Office Action Summary

10/743,091

NISHIMURA ET AL

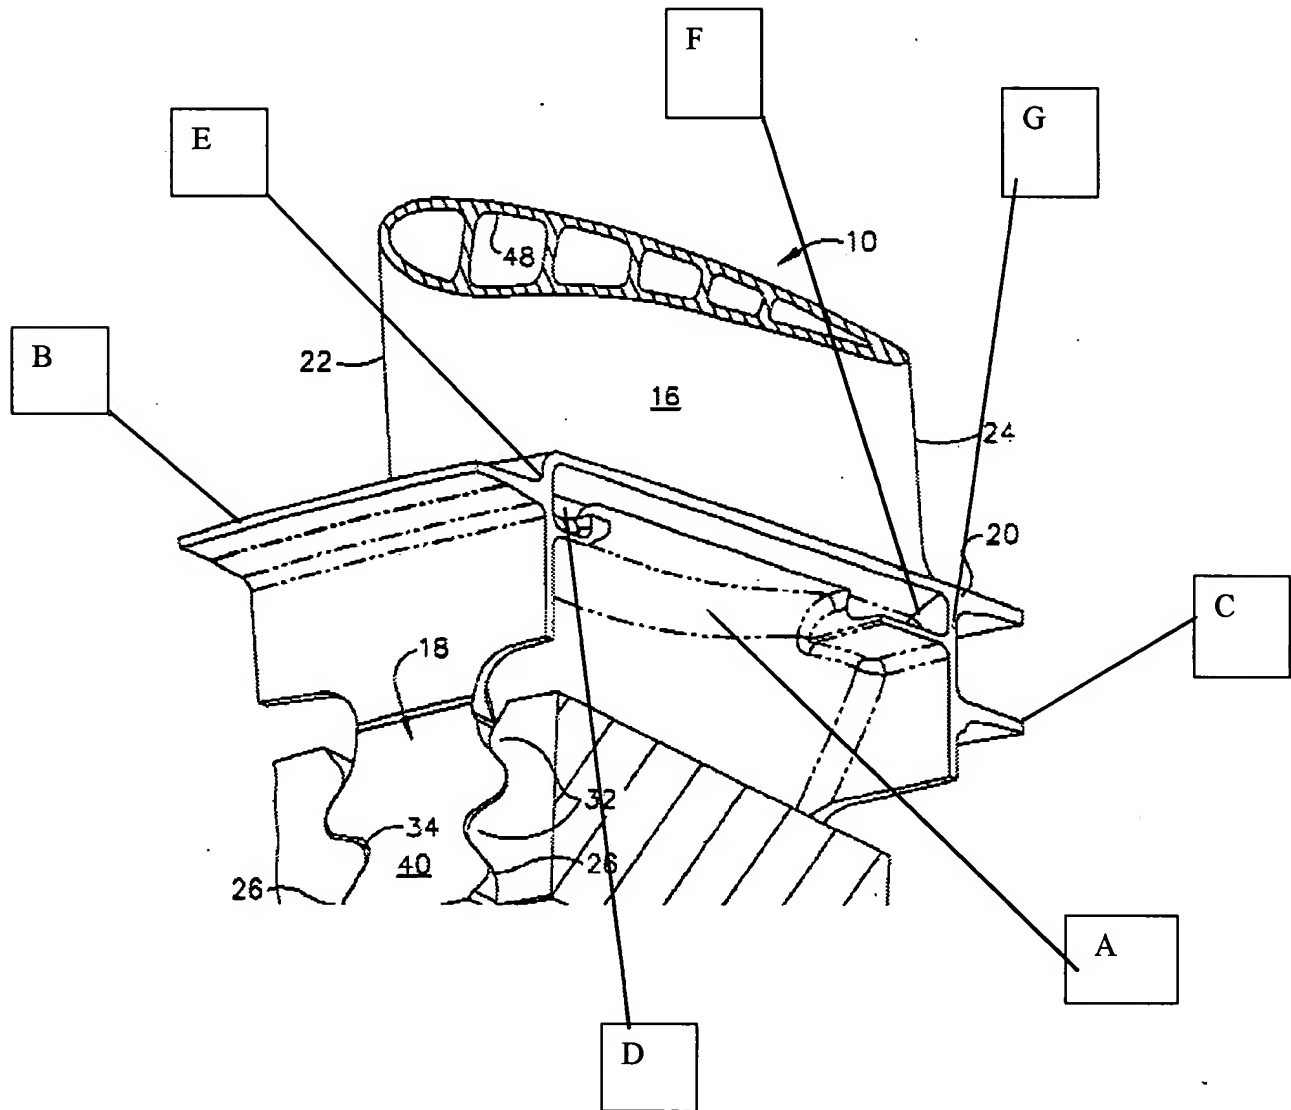
Claims 1-2 and 9 are rejected under 35 U.S.C. 102(e) as being anticipated by Herman 6,786,696 (see the annotated figure at the end of this paragraph). Note the turbine blade 10 to be installed into an engaged member 28 of a turbine disk 30 of an aircraft engine comprising a blade 10, one side of which having a convex suction surface and the other side of which having a concave pressure surface, a platform 20 on a hub side of the blade, a recess A being formed on one side of the platform, a front seal fin B formed protruding forward at the front end of the platform, and a rear seal fin C formed protruding backward at the back end of the platform, an engagement member 18 on the hub side of the platform, the engagement member having an engagement face 26 which is able to be engaged with the engaged member 28, a front engagement member D in the vicinity of a base portion of the front seal fin, the front engagement member having a front engagement face able to engage with a front locating portion of a jig to be used for grinding, and the front engagement face located back from a virtual plane including the one side of the platform; a front wall E in the vicinity of the base portion of the front seal fin, the front wall surrounding a front side-edge portion of the front engagement member, a rear engagement member F in the vicinity of a base portion of the rear seal fin, the rear engagement member having a rear engagement face able to engage with a rear locating portion of the jig, and the rear engagement face located back from the virtual plane, and a rear wall G in the vicinity of the base portion of the rear seal fin, the rear wall surrounding a rear side-edge portion of the rear engagement member, wherein an end face of the front wall and an end face of the rear wall are respectively configured to be coplanar with the virtual plane. The front engagement face and the rear engagement face are respectively configured to be substantially parallel to the longitudinal

direction of the engagement member 18. The engaged member is a female dovetail 28 and the engagement member is a male dovetail 26. The recitation in claim 1, line 5 of the platform integrally molded on a hub side of the blade, in claim 1, lines 10-11 of the engagement member integrally molded on the hub side of the platform, in claim 1, lines 12-13 of the engagement face being formed by grinding, in claim 1, lines 13-14 of the front engagement member integrally molded in the vicinity of the base portion of the front seal fin, in claim 1, lines 19-20 of the front wall integrally molded in the vicinity of the base portion of the front seal fin, in claim 1, lines 22-23 of the rear engagement member integrally molded in the vicinity of a base portion of the rear seal fin, and in claim 1, lines 27-28 of the rear wall integrally molded in the vicinity of the base portion of the rear seal fin, are product-by-process limitations and do not distinguish over Herman. Even though product-by-process claims are limited by and defined by the process, determination of patentability is based on the product itself. The patentability of a product-by-process claim does not depend on its method of production. If the product in the product-by-process claim is the same as or obvious from a product of the prior art, the claim is unpatentable even though the prior product was made by a different process. *In re Thorpe*, 777 F.2d 695, 698, 227 USPQ 964, 966 (Fed. Cir. 1985). The recitation in claim 1, lines 15-16 of the front engagement member front engagement face able to engage with a front locating portion of a jig to be used for the grinding, and the recitation in claim 1, lines 24-25 of the rear engagement member rear engagement face able to engage with a rear locating portion of the jig are recitations of intended use. A recitation of the intended use of the claimed invention must result in a structural difference between the claimed invention and the prior art in order to patentably distinguish the claimed invention from the prior art. If the prior art structure is capable of
